THE MULBERRY HOUSE SCHOOL, SHOOT UP HILL, LONDON NW2 3XL

Report to the Planning Officer: Zenab Haji-Ismaail

20 May 2016

B PROPOSED AMENDMENTS TO PLANNING PERMISSION NO. 2015/5184/P

Alteration to Elevation C – changed level of the underside of the top chord of the steel truss behind the glazing

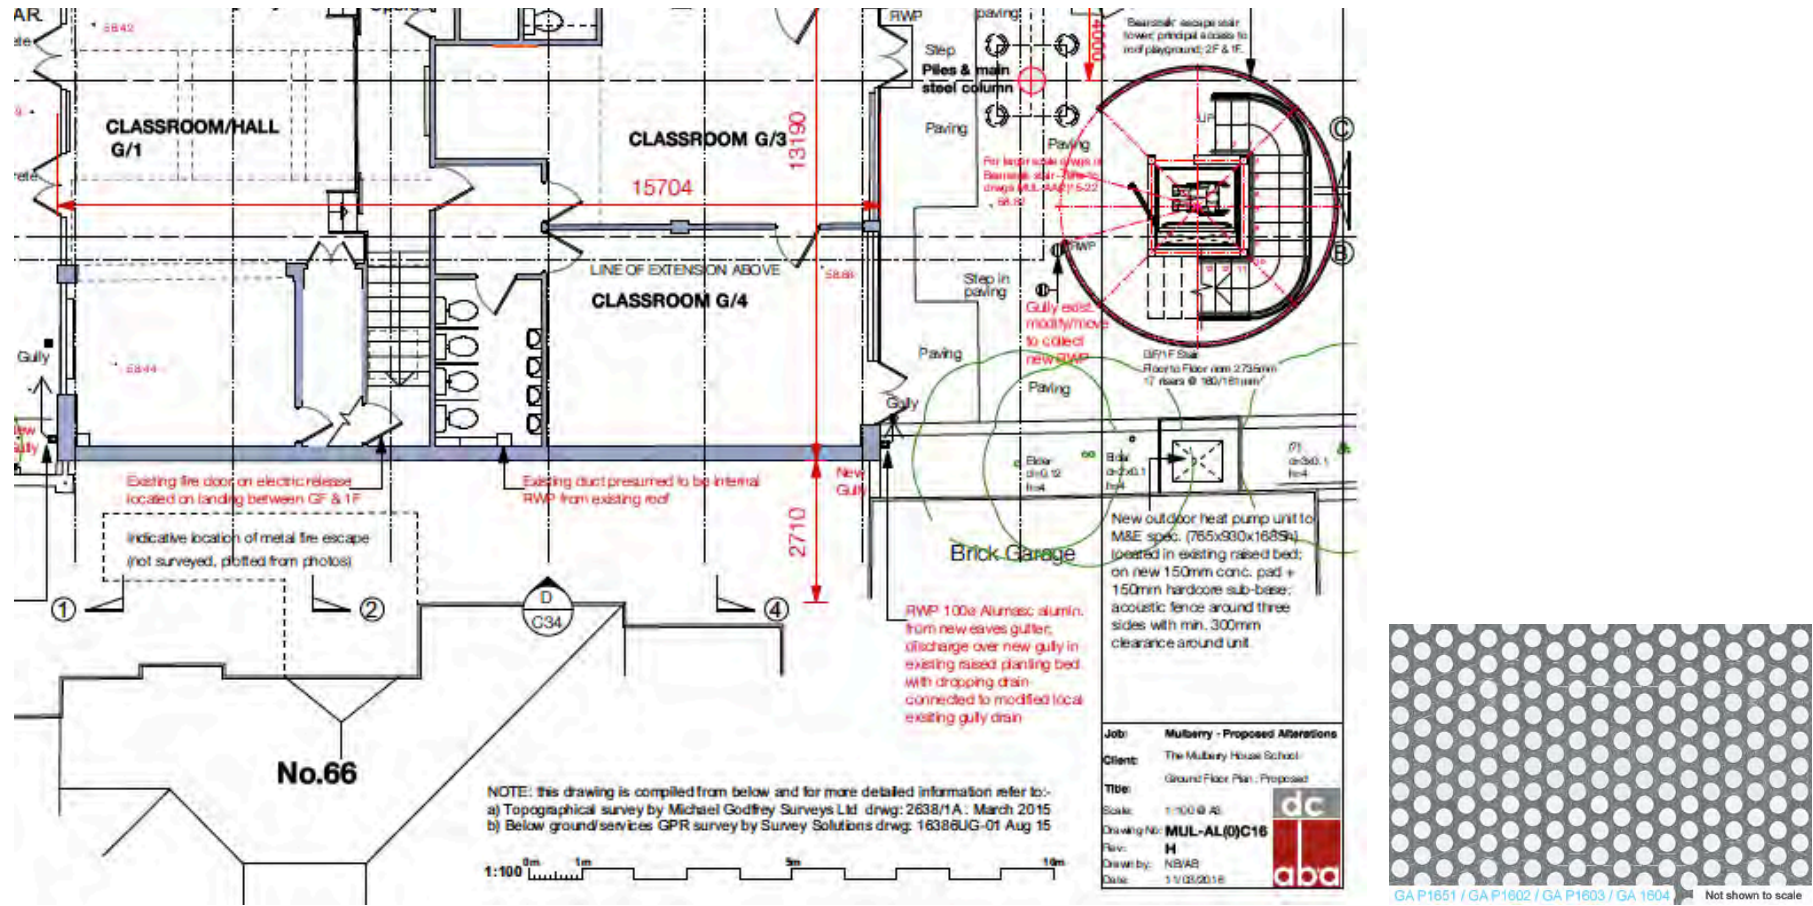
1 Alteration to Elevation C

Due to necessary changes in the structural design of the steel truss (that lies behind the glass façade) there will be a reduction in the truss's height to Level 68.00 (glazing now more consistent). I attach the revised elevation (MUL-A(0)C33) at page 5 of this report.

Location of heat pump and material for visual-only enclosure (as there are no requirements for acoustic treatment) to the side of the 'Beanstalk'

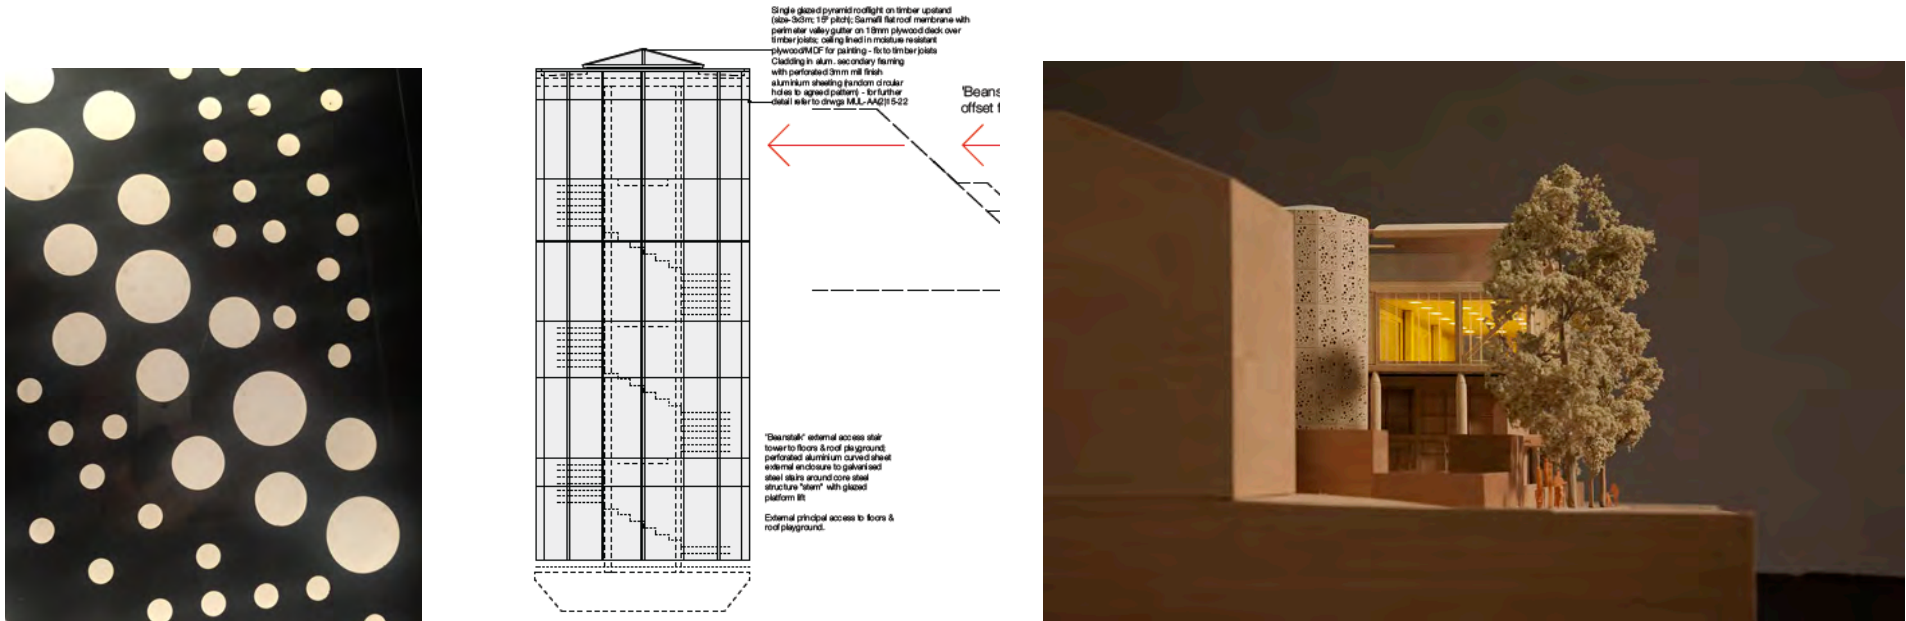
3 Heat pump and enclosure

During design development, it has become necessary / desirable to utilise a Heat Pump for the generation of energy for the building's ventilation systems. This will be located to the rear side of the Beanstalk on the low wall adjacent to the garage wall to 66 Shoot Up Hill. On 23 April 2016 the M&E Engineers for the building p3r (Mike Popper) wrote: "**Doug ... they (Gillieron Scott Acoustic Consultants) have confirmed that no acoustic measures are required.**" The enclosure therefore will be visual only – of mill finish natural aluminium construction (as 4). I attach part of drawing (MUL-A(0)C16) and proposed material at page 7 of this report.

Cladding to the 'beanstalk' stair and lift altered to perforated aluminium to satisfy the Building Control Officer on spread of fire

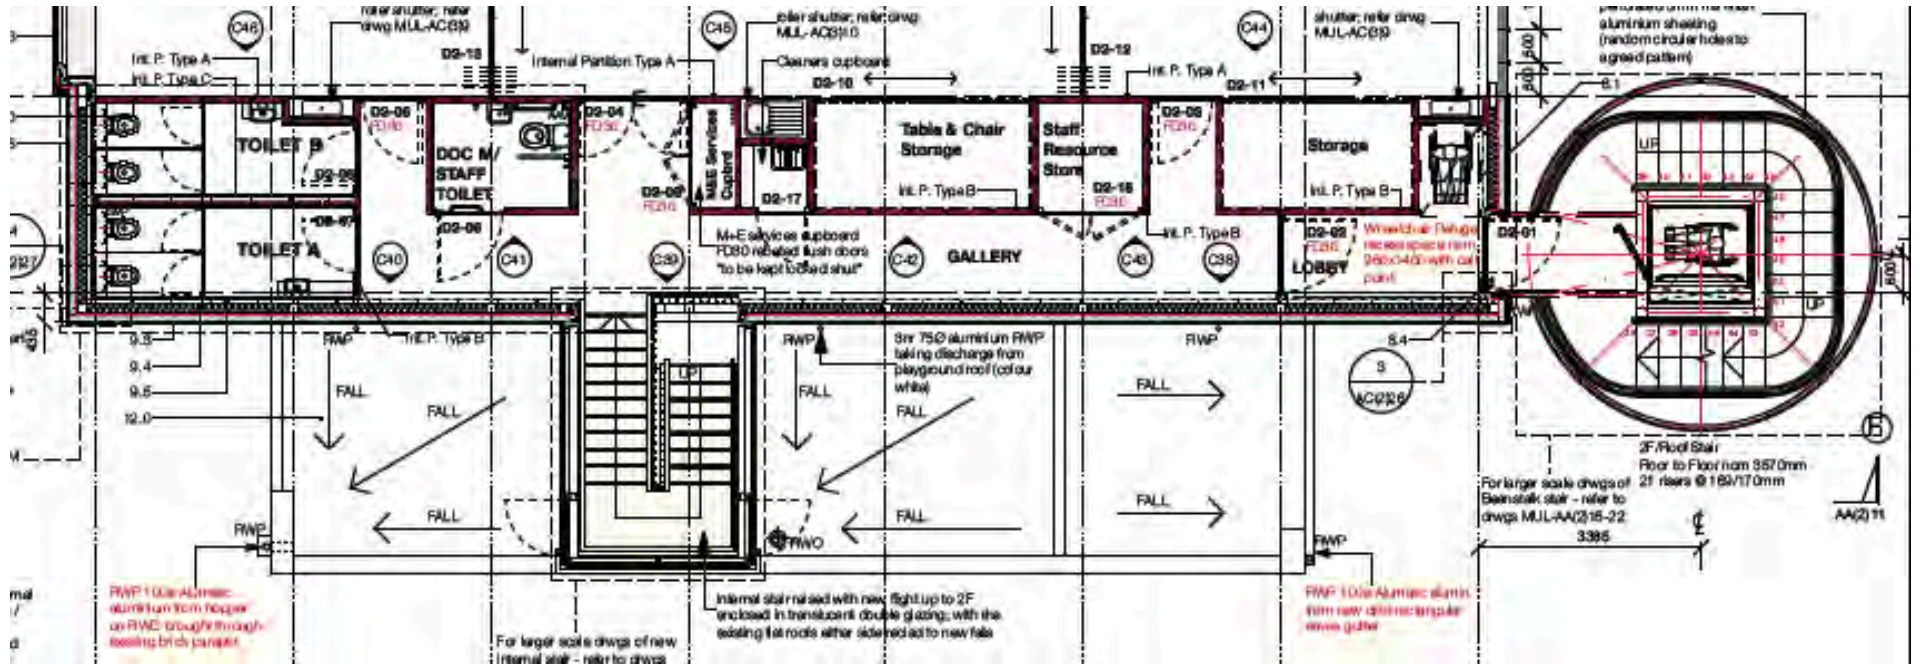
4 Cladding to the 'beanstalk' stair and lift altered to satisfy the Building Control Officer

Due to flame-spread reasons, the use of polycarbonate to clad the 'Beanstalk' lift and stair element does not meet the requirements of the Building Regulations. We therefore propose to use a mill finish natural aluminium sheet (as 3), but with differing sized perforations as cladding. I attach an example of the type of holes to be used (differing sizes – differing sized kids) to be in natural aluminium and not black as illustrated; the relevant elevation (part of drawing MUL-A(0)C32; and a photograph of the model of the building that shows the 'Beanstalk'. These are found on page 8 of this report.

Removal of small areas of green roof on existing building on both sides of the internal stair due to structural limitations

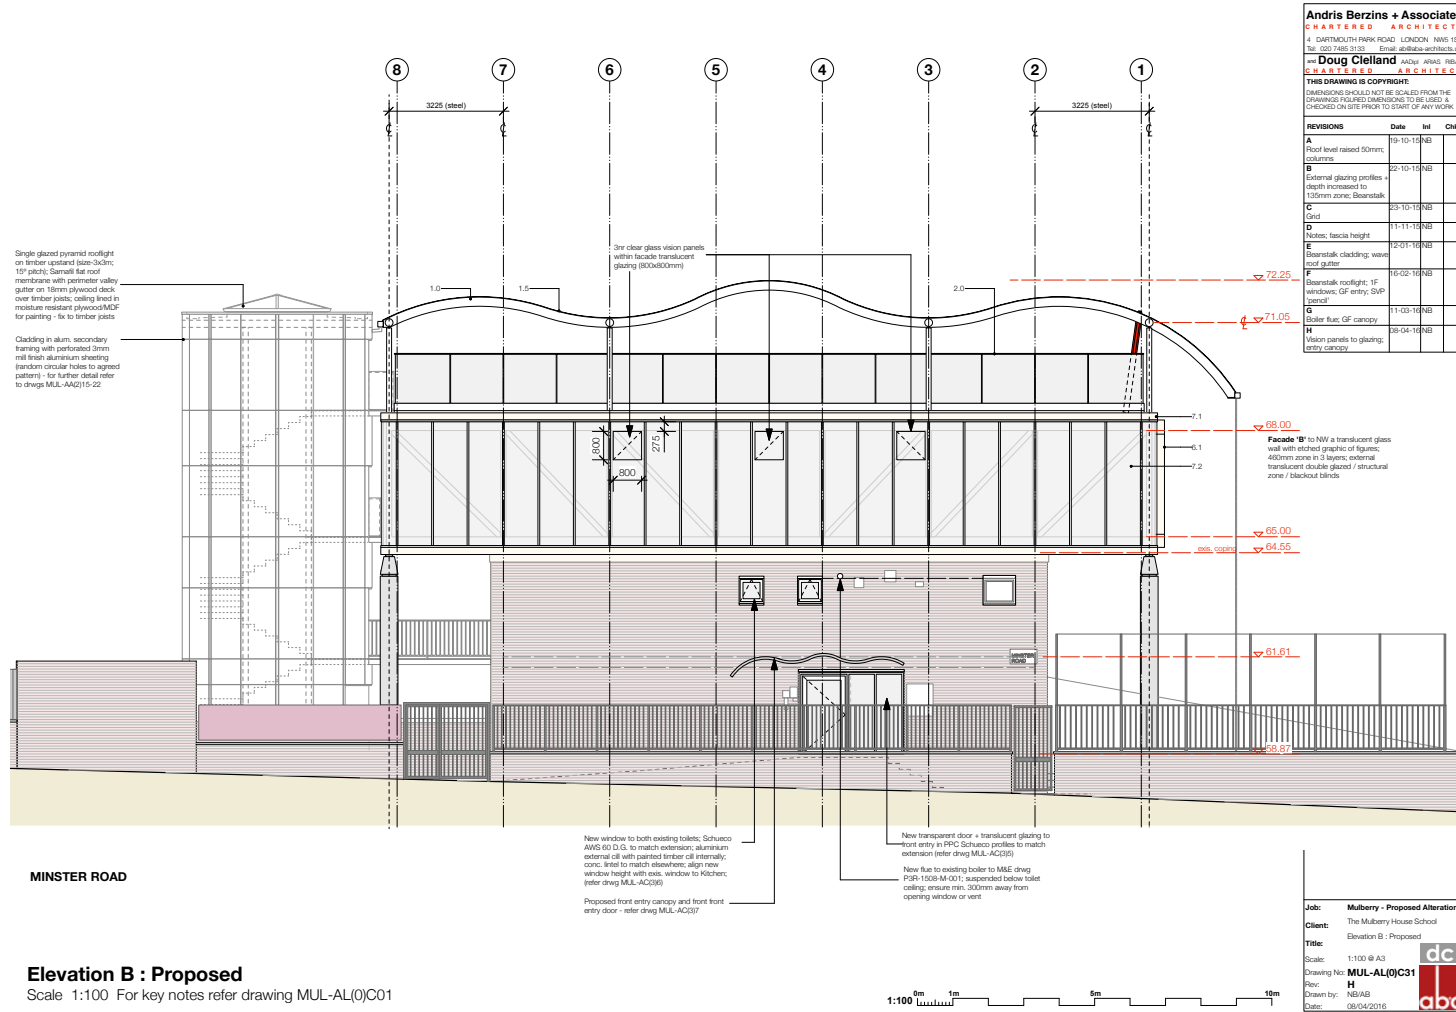
5 Removal of small areas of green roof on existing building due to structural limitations

Due to the limited structural carrying capacity of the existing roof of the school, the proposed extension building spans across the existing superimposing zero stresses on the existing walls. This limitation also affects the original intention to have two small areas of 'green roof', one on either side of the internal stair. As these small parts of the project will not be visible from inside the building or indeed significantly from the surrounding buildings, a single membrane roof will replace the existing felt roof and will not result in a significant loss. I attach an extract of the roof plan of the affected areas (MUL-A(0)C18) at page 9 of this report.

Two small windows added to existing building to provide light and ventilation to toilets

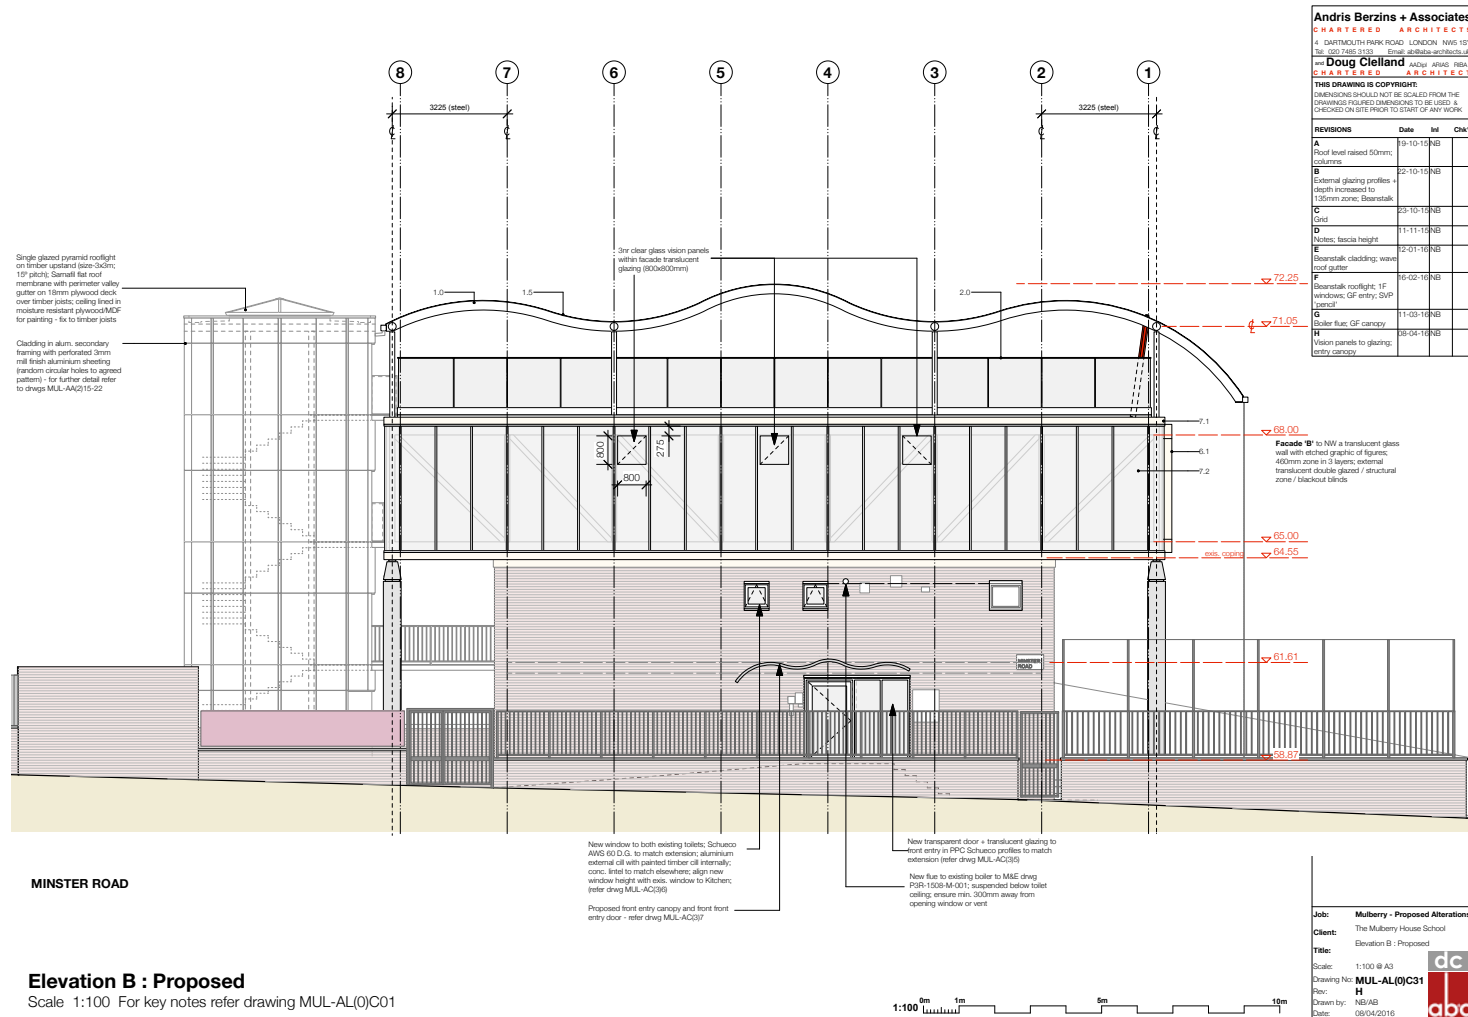
- 6 Two small windows added to existing building to provide light and ventilation to toilets**
Due to the removal of a rooflight to enable the construction of the extension, there are two toilets on the Minster Road side of the school that are now in darkness, requiring artificial light and therefore energy consumption at all times of the day. It is therefore proposed that two small windows are introduced into the existing wall, sized with the existing kitchen window in mind. I attach the revised elevation MUL-A(0)C31H at page 10 of this report.

Three small vision panels to Classroom 2 in the translucent glazing on Minster Road

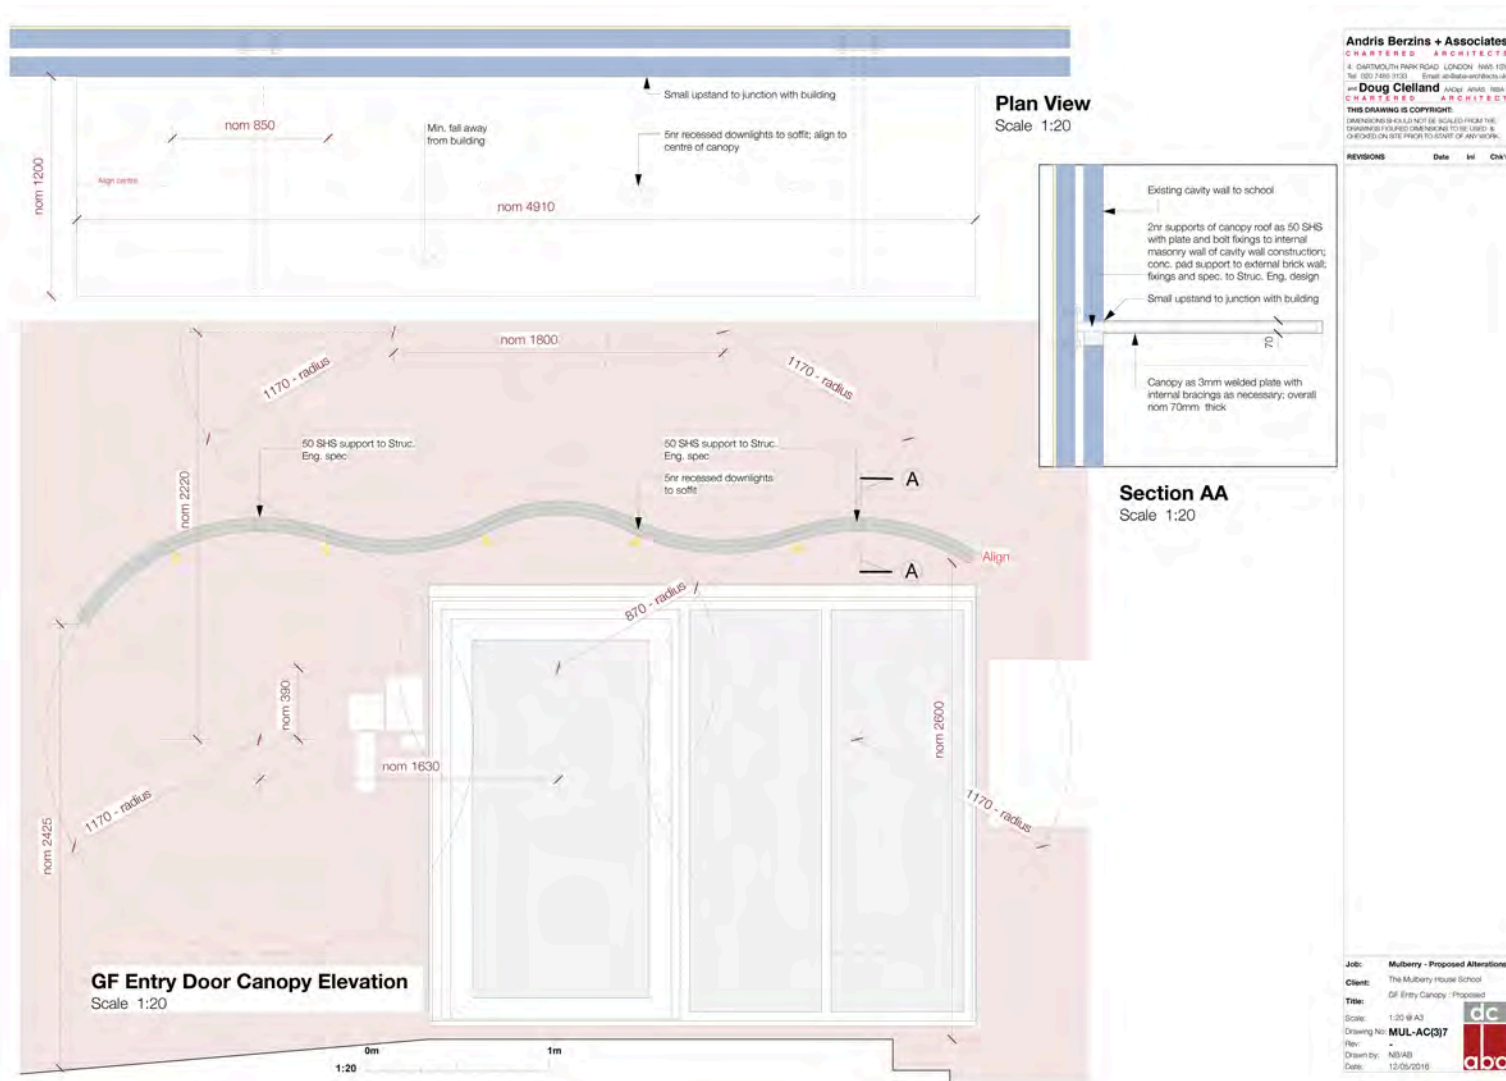
- 7 Three small vision panels to Classroom 2 in the translucent glazing on Minster Road**
It is good practice that inhabitants of a building have orientation to the external environment. While the new classrooms facing the front and the rear of the extension have both transparent and translucent glazing, the classroom in the centre only has translucent glazing in the permitted design. We therefore propose the introduction of three high-level transparent vision panels to provide views of the sky. The attached elevation MUL-A(0)31H at page 11 indicates these proposals. I also attach a view of these on the model at page 12.

New canopy

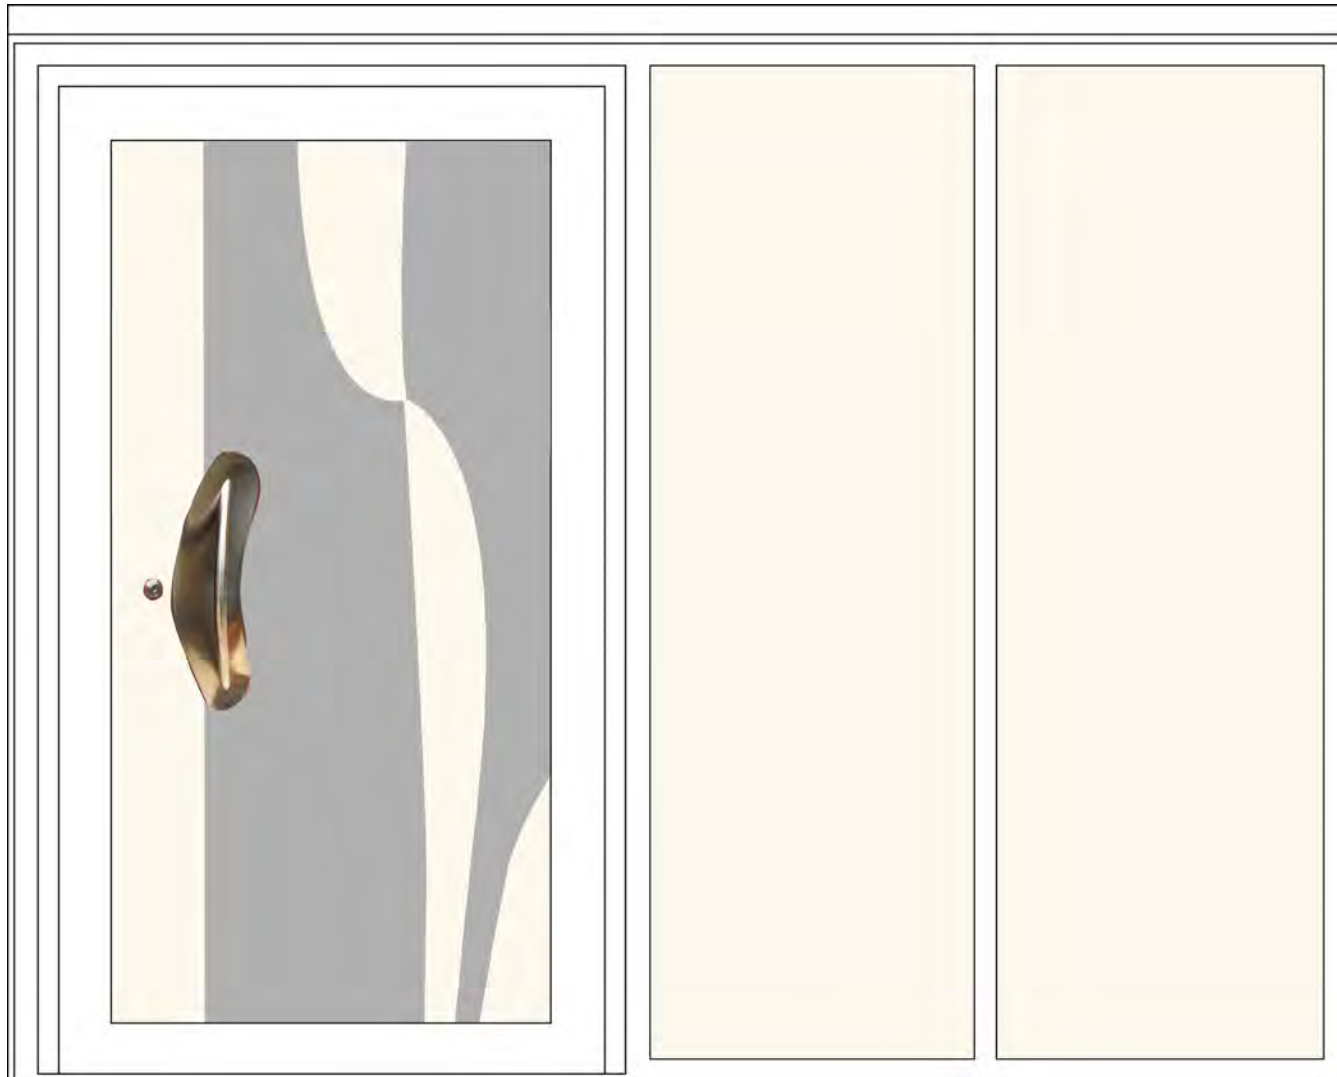
- 8 New front door screen and canopy**
To provide protection from weather, a canopy is proposed as a miniaturisation of the 'Cloud' roof over the roof play area. I attach drawing MUL-AC(3)7 illustrating this canopy and its generating geometry at page 13 of this report. A new front door to replace the – 'tired' – existing one is proposed. This will be etched in glass to the design found on page 14 of this report.
